Request IR-1:

Refer to M12861, Exhibit-N1-Nova Scotia Power Inc. 2026 Load Forecast Report (filed May 15, 2026) (the “Report”), Figure 37, and respond to the following:

2026 Load Forecast Report (NSEB M12861)
NSPI Responses to Solar Nova Scotia Information Requests

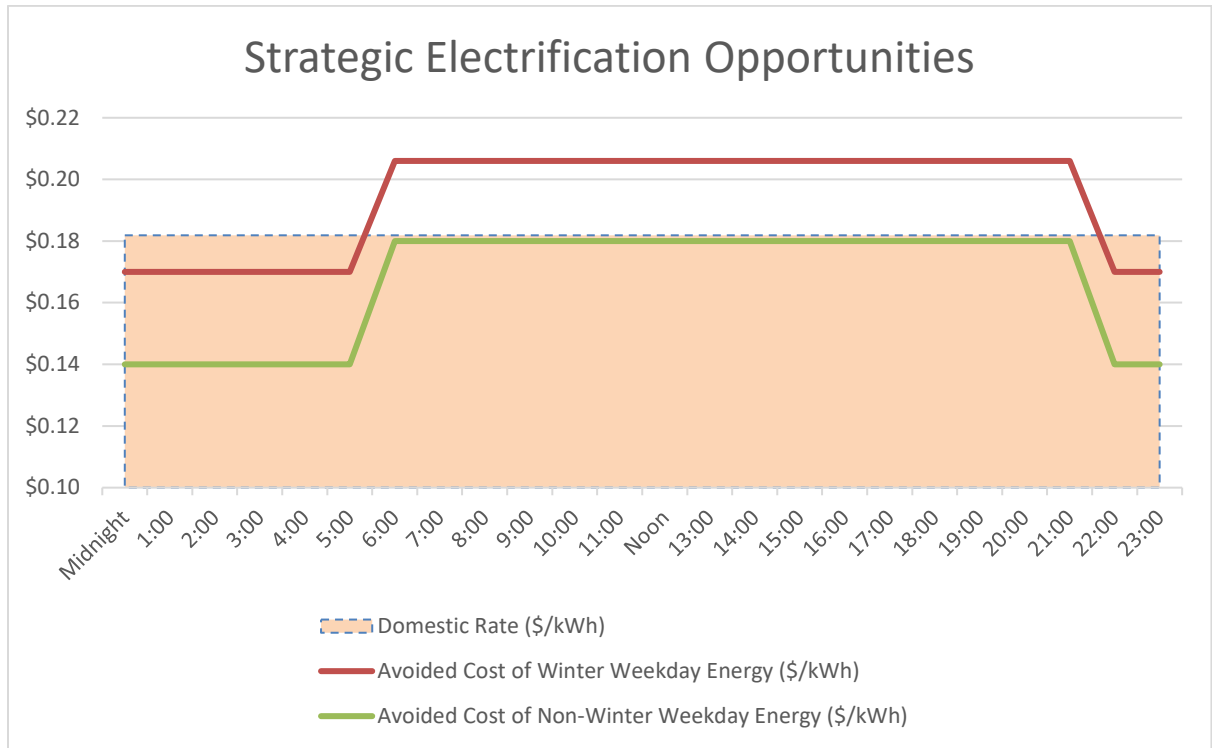
- (a) The Report states that strategic electrification now falls within the DSM definition, but no strategic electrification initiatives are included in the proposed 2027–2031 DSM Plan. Please identify the analyses and data, including avoided-cost inputs, load shapes, marginal emissions, grid-constraint information and customer segmentation, that NS Power has provided or could provide to EfficiencyOne to enable strategic electrification initiatives to be included in the 2027–2031 DSM Plan.**

Prior to E1’s filing of its 2027-2031 DSM Plan, NS Power provided E1 with the following figure which illustrates the relative value of SE through the Domestic standard offer rate compared with the cost of energy, using the avoided-cost of energy efficiency (EE) series (as was used by E1 in their SE modeling). The purpose of the diagram is to demonstrate that SE could be enabled by targeting times when system energy cost is below the standard offer rate. Targeting electrification measures to those hours is expected to provide a benefit, assuming program costs and demand impacts can be minimized. NS Power also noted that material spreads exist in the EE avoided cost series during off-peak hours and on weekends, especially during the non-winter (April to October) period.

NS Power recommended examining additional cases that electrify these off-peak, non-winter hours. Historical hourly usage patterns indicate there are opportunities in heat pump heating, resistive electric water heating, and EV charging, provided peak demand mitigation is maximized, and program costs minimized. For example, cooling from heat pumps supports SE as it does not contribute to peak demand. NS Power also noted that electrification of transportation loads is highly flexible and generally higher in the non-winter period and suggested it would be beneficial for E1 examine transportation electrification measures in its SE modelling.
